Project Address: 529-557 State Street, 431-441 North Frances Street, and 432 West Gilman Street
Application Type: Demolition, Rezoning, and Conditional Use
Legistar File ID # [30040](#), [30532](#) and [30660](#)
Prepared By: Heather Stouder, AICP, Planning Division
Report Includes Comments from other City Agencies, as noted

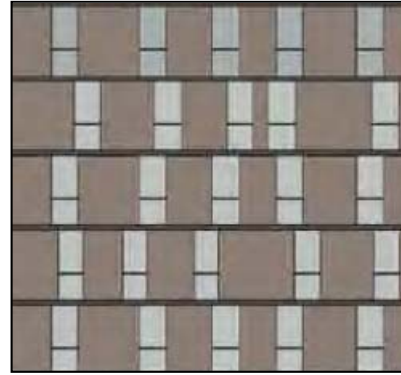
f) On the State Street tower facade (and similar facades as the building turns toward Gilman), explore the use of additional glass, and explore additional articulation through a plane change or additional balconies.

The applicant’s execution of this recommendation (see Option C on the next page) may be consistent with the Urban Design Commission (to be determined on August 7), but with regard to the window pattern, it is not consistent with recommendations by staff or the Plan Commission (Option B). Specifically, the applicant has proposed a strategy to integrate additional glass on the State Street tower facade (and the Frances Street tower facade) by integrating a new window type wider than the other windows on the building. The design now includes pairings of wide and narrow windows, alternating back and forth from floor to floor, as shown at right. The fluctuation in window type, and especially the alternating pattern moving up the facade, is an architectural feature that has no relationship to interior function or layout. Further, the Gilman Street elevations still have the random window pattern originally proposed.

Option A (State Street Tower with Random Window Pattern – Original Submittal)

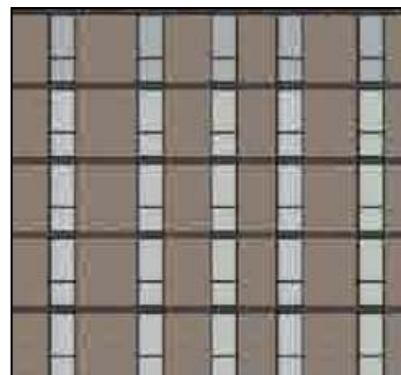
Staff appreciates the addition of more glass on the State Street tower facade. Option C is an improvement over the original submittal (Option A), but staff does not prefer the combination of mixing window types horizontally and alternating their position from floor to floor.

Option B (State Street Tower with Linear Window Pattern - Recommended by Staff)

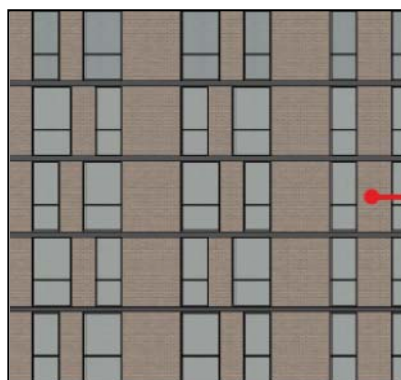
Instead, staff continues to believe that a linear window pattern on all facades of the tower (Option B) will best contribute to a timeless design on this prominent

Downtown building. This would be consistent with the original staff recommendation and the recommendation by the Plan Commission to the Common Council, especially if additional glass could be incorporated within this pattern. Should the Council approve the window pattern in Option C, staff recommends that the treatment on State Street tower facade be replicated on facades of the building still shown with the original random window pattern.
